MEETING NOTICE

A meeting of the
Bayside Local Planning Panel
will be held in the Committee Room, Botany Town Hall
Corner of Edward Street and Botany Road, Botany
on **Tuesday 12 February 2019 at 6:00 pm.**

Bayside Local Planning Panel

12/02/2019

Figure 5 - Proposed front landscaped area
Source: Landscape Plan BKA Architecture

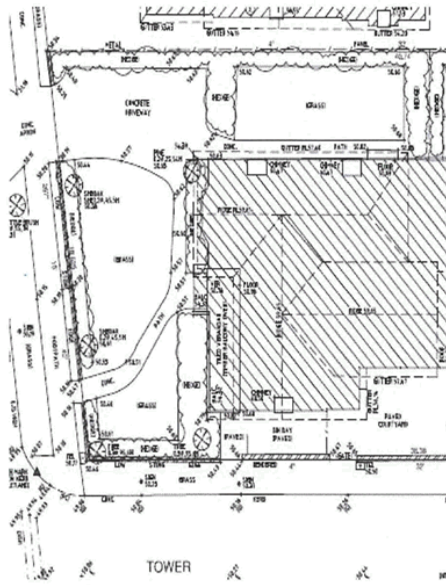
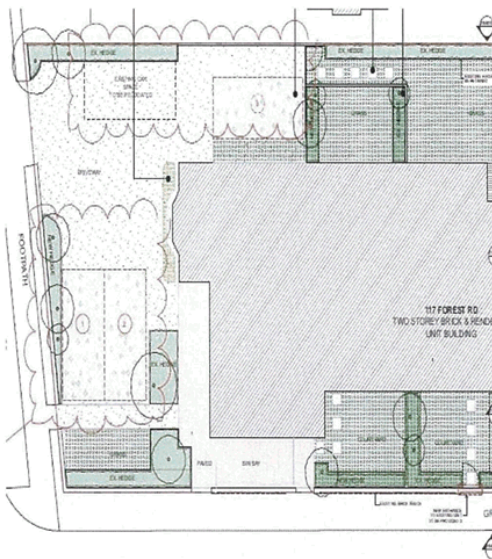
In addition to the above, the proposal is utilising the front setback and front curtilage of the existing building for carparking. The existing limited concrete area on the Forest Road frontage will be significantly increased to allow maneuvering of vehicles and the addition of two carparking spaces. The existing carparking space will be relocated behind the building line reducing the landscaped area further. Refer to figures below. One of the carparking spaces is to be provided for one of the new units at the rear, which is not practical as there is no access to the carparking space from within the property. The provision of additional parking at the front is to the detriment of the existing attributes of the streetscape and is not supported.

Figure 8. Proposed location of fire control room and fire hydrant booster system

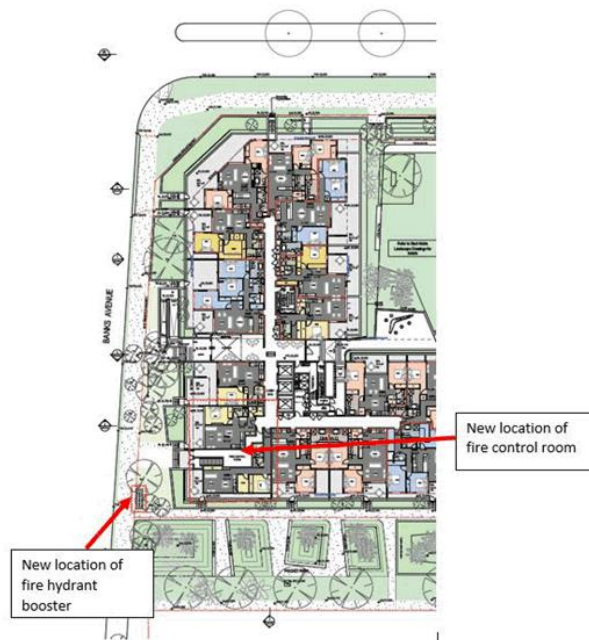
It should be noted, in order to comply with *Clause E1.3 of the Building Code of Australia (BCA) and Australian Standard (AS2419-2005)*, the location of the hydrant booster and fire control room needs to be relocated to face Banks Avenue, thus resulting in further minor modifications to the approved internal layout of Building A main lobby and approved apartments G26, G08 and G10.

Figure 9. Proposed changes to the ground floor

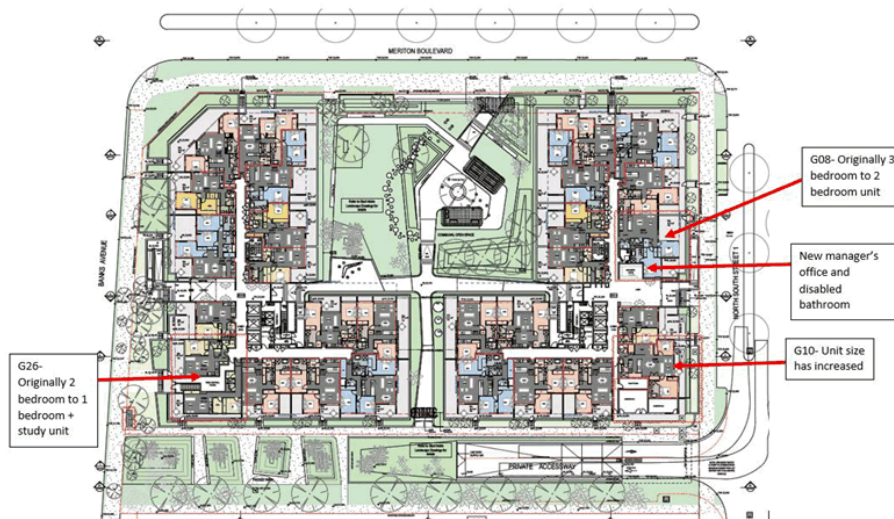
The changes are highlighted in red bubble as demonstrated within Figure 9 below.

Figure 10. Proposed changes to the basement car parking level

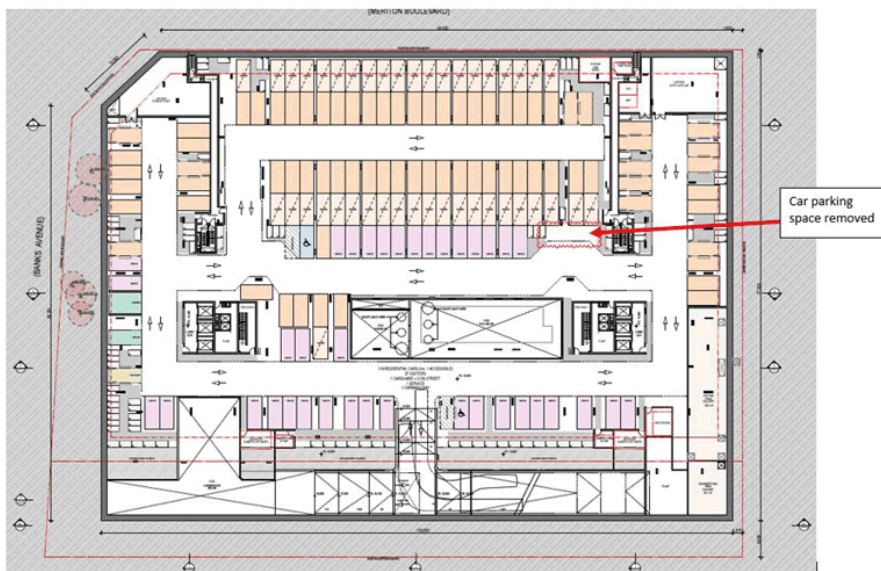
The changes to the unit mix results in changes to the car parking requirements. As Unit G08 and G26 lose one bedroom within the development, each unit loses half a car parking space. This results in one car parking space to be lost and the applicant has proposed its removal within the basement car parking layout. The original DA approved a total of 591 car parking spaces which includes residential, car share, visitor spaces, courier and loading spaces and car wash bay. The proposal provides a total of 588 car parking spaces within the basement which results in a loss of one car parking space for the reasons provided above. The space lost within the basement level is demonstrated in the figure below. Two of the car parking spaces are provided on street for car share. The overall number of car parking spaces has not been altered within conditions as the condition outlines the minimum residential car parking requirement. The original DA approved an excess of residential car parking therefore the proposal continues to comply with the car parking requirements under the Stage 1 consent.

Figure 1: Fire hydrant booster location

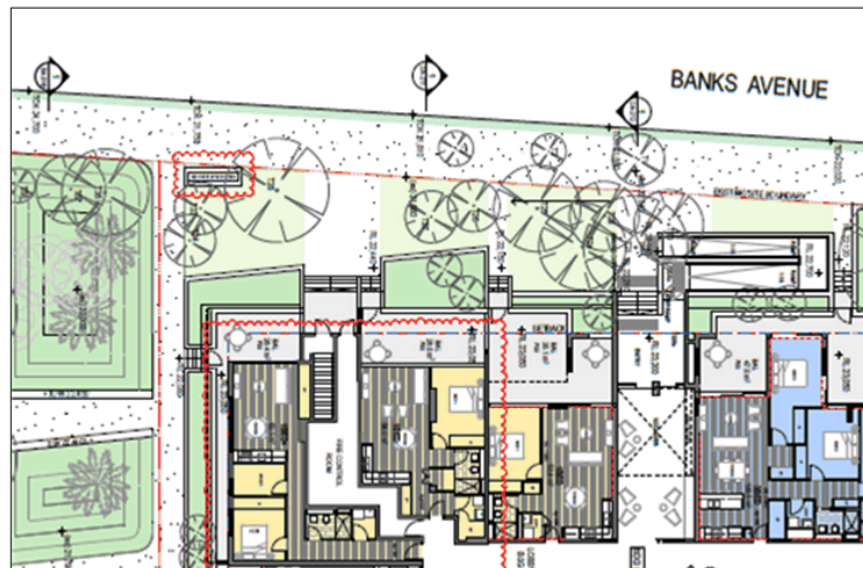
Fire and Rescue NSW have reviewed the architectural plans approved under Condition 1 in Development Consent No. 2017/1224 and have identified that the fire hydrant system proposed for the subject development is not compliant with *Clause E1.3 of the Building Code of Australia (BCA) and Australian Standard (AS2419-2005)*.

In response to the advice provided by Fire and Rescue NSW, the hydrant booster and fire control rooms shall be relocated to face Banks Avenue with a Fire Resistance Level (FRL) of 90 minutes. Figure 1 below shows the location of the fire hydrant booster as requires by Fire and Rescue NSW.
